REFERENCE:	Nova Bus Manuals
SECTION:	16: V-BEA (Volvo bus electronic architecture)
RS N°:	MQR 7621-674
EFFECTIVE IN PROD.:	L840 (2014SE)

SUBJECT:	Replacment of V-BEA IO/A or IO/B module
JUSTIFICATION:	A new procedure is available to reprogram a new IO/A or IO/B without a laptop

Figure 1 - Switches to Activate New IO Module Reprogramming

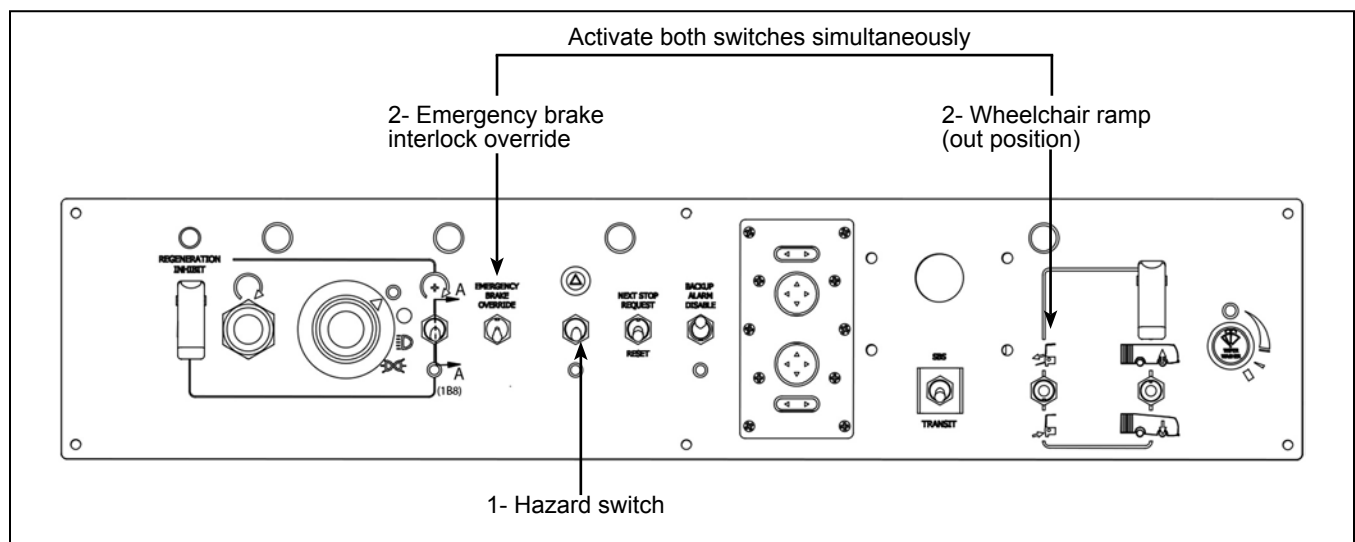
- 1.5. Set the **HAZARD FLASHER** switch to **ON**.
- 1.6. Simultaneously activate the **EMERGENCY BRAKE INTERLOCK OVERRIDE** and **WHEELCHAIR RAMP** (out position) switches. See Figure 1.

Figure 2 - Network Tell-Tale and Actia Speedometer Display to Validate IO Module Reprogramming

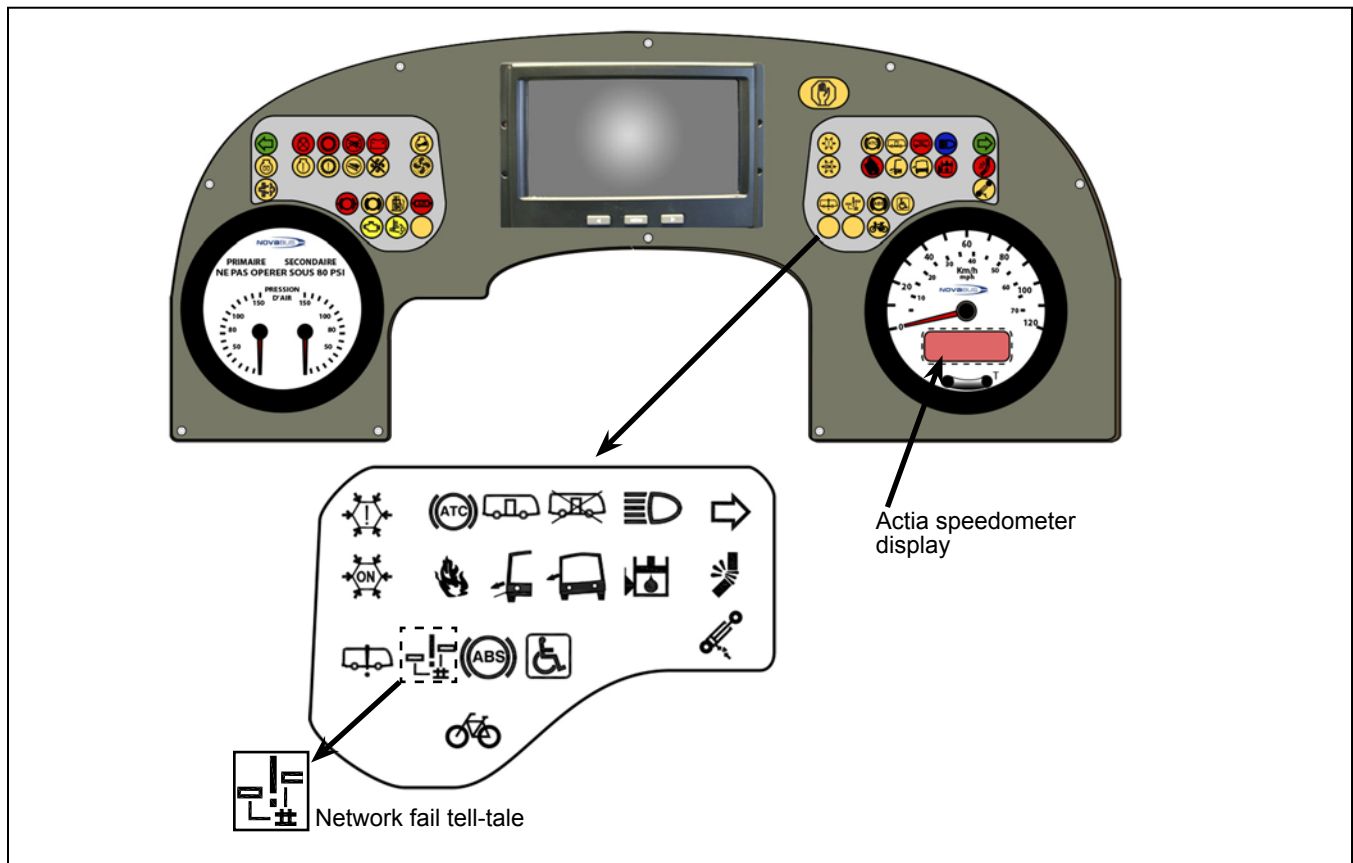
- 1.7. Wait 5 minutes and place the **MASTER CONTROL SWITCH** in the **ON** position.
- 1.8. Check that the **NETWORK FAIL** tell-tale is not lit up to ensure IO modules are reprogrammed. If the tell-tale is not lit up, the newly installed IO module is reprogrammed. See Figure 2.
- 1.9. If the **NETWORK FAIL** tell tale is lit up, validate whether the new IO module is faulty in the Actia speedometer display. If the newly installed module is not reprogrammed, a fault corresponding to the module number will be displayed in the Actia speedometer display. Redo the entire procedure except step 1.3 if the newly installed IO module is coded. See Figure 2. ❖
